May 1, 2009
NND-09-0109

Subject: Virgil C. Summer Nuclear Station (VCSNS) Units 2 and 3 Combined License Application (COLA) - Docket Numbers 52-027 and 52-028 Response to NRC Request for Additional Information (RAI) Letter No. 041

SRP Section: 2.4.12 – Groundwater

Figure 2.4-246 Hydraulic Conductivity vs. Depth and Hydrostratigraphic Zone

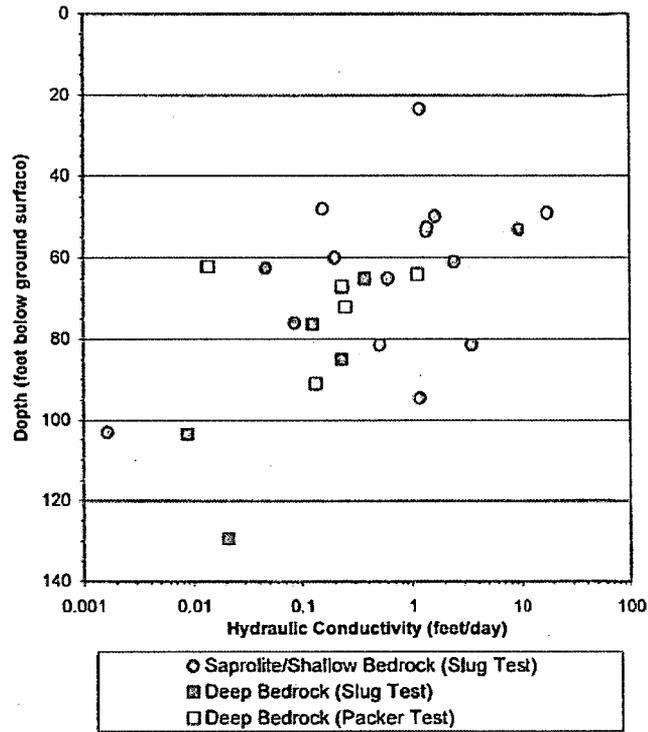
Staff requests that the applicant provide (in electronic format) the AQTESOLVE input files that were used in the slug test analysis for determining hydraulic conductivity.

The thirty-four (34) AQTESOLV input/output files for the slug test results presented in FSAR Table 2.4-218 have been made available to the NRC (Letter from Ronald B. Clary to the Document Control Desk, NND-09-0104, dated April 29, 2009). Please note that one output value from AQTESOLV (for observation well OW-623) was incorrectly transcribed into Revision 0 of FSAR Table 2.4-218. The value is shown as 1.8E-5 cm/s where it should have been shown as 1.8E-4 cm/s for the falling head test. This transcription error impacts the summary statistics only slightly and does not impact the radionuclide transport calculation in FSAR Subsection 2.4.13 (which used the 75th percentile value of hydraulic conductivity). FSAR Table 2.4-218 will be corrected in the next revision of the FSAR.

The remaining 21 slug test results were analyzed and low, high, and geometric mean values were calculated for each of the hydrostratigraphic zones. The saprolite/shallow bedrock hydrostratigraphic zone tests were completed in saprolite, partially weathered rock, or a combination of both. Based on 16 slug tests, hydraulic conductivity values for this zone vary from 0.0017 feet/day to 18 feet/day with a geometric mean for this zone of 0.600.62 feet/day. The deep bedrock hydrostratigraphic zone tests were completed in sound rock. Based on five slug tests, the hydraulic conductivity values for the deep bedrock zone vary from 0.0088

feet/day to 0.38 feet/day with a geometric mean for this zone of 0.07 feet/day. Figure 2.4-246 is a graph of hydraulic conductivity versus depth and hydrostratigraphic zone. This plot indicates that within the saprolite/shallow bedrock zone the hydraulic conductivities do not vary much with depth; however, in the deep bedrock zone, hydraulic conductivities decrease with depth.

Table 2.4-219 gives the results of packer tests conducted in selected geotechnical borings. These tests were conducted in the deep bedrock hydrostratigraphic zone. The hydraulic conductivity values for the deep bedrock zone from the packer tests vary from 0 to 1.14 feet/day with a geometric mean value of for this zone is 0.166 0.17 feet/year-feet/day. Some hydraulic conductivity values are listed as zero. This is a result of a test conducted in a zone that did not take any water. This geometric mean hydraulic conductivity value of the packer tests is higher than the 0.07 feet/year-feet/day geometric mean hydraulic conductivity value indicated by the slug test results for the deep bedrock zone. The differences in values measured by the two tests are interpreted as a result of the depths at which the tests were conducted. The packer tests were generally conducted at shallower depths than the slug tests. The hydraulic conductivity values of the deep bedrock zone increase at shallower depths. When compared with just the shallow slug test results, the packer test values and the slug test values are in much closer agreement (Figure 2.4-246).

FSAR Figure 2.4-246 will be revised as shown in the attached figure.
